COMMUNITY DEVELOPMENT DEPARTMENT

SUBJECT: FP-2021-0032
Apex Southeast No. 2

Final plat consisting of 78 single-family residential buildable lots and 21 common lots on 20.34 acres of land in the R-8 zoning district.

B. Final Plat (dated: 4/9/21)

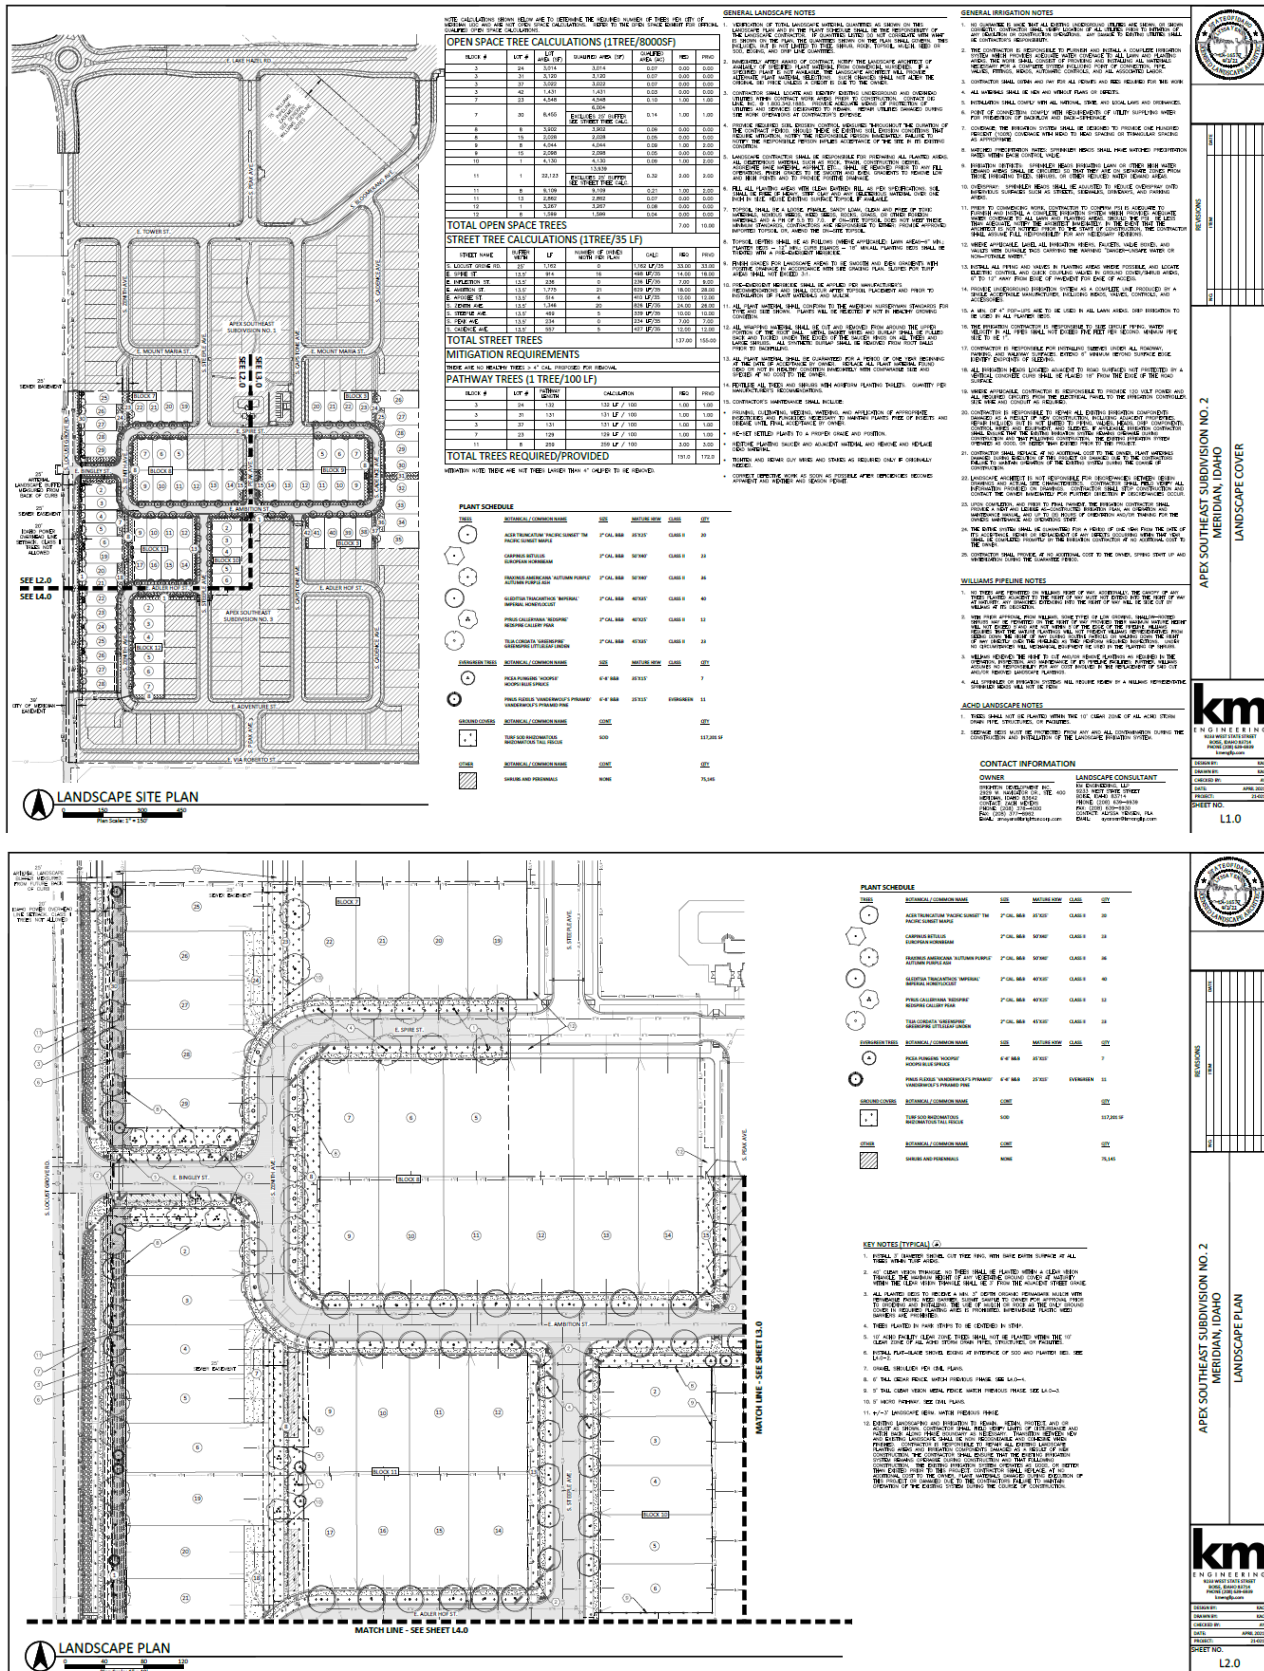
References (Sheet 1):

- a. R1 – Include the Book and Page numbers of the Apex Southeast Subdivision No. 1 plat.

Notes (Sheet 3):

- b. Note #6: Clarify the last sentence of this note. It appears that "6." is misplaced.
- c. Note #10: Include the recorded instrument number of the ACHD landscape license agreement.
- d. Note #11: Include the recorded instrument number of the ACHD public right-of-way easement.
- e. Note #12: Strike note (not in this phase)
- f. Note #13: "Direct lot or parcel access to S. Locust Grove Rd. ~~and E. Lake Hazel Rd.~~ is prohibited. . ."
- g. Note #16: Does Lot 1, Block 11 contain the referenced easement? If not, delete.
- h. Note #17: Include the recorded instrument number of the CC&R's.

A copy of the revised plat shall be submitted with the final plat for City Engineer signature.
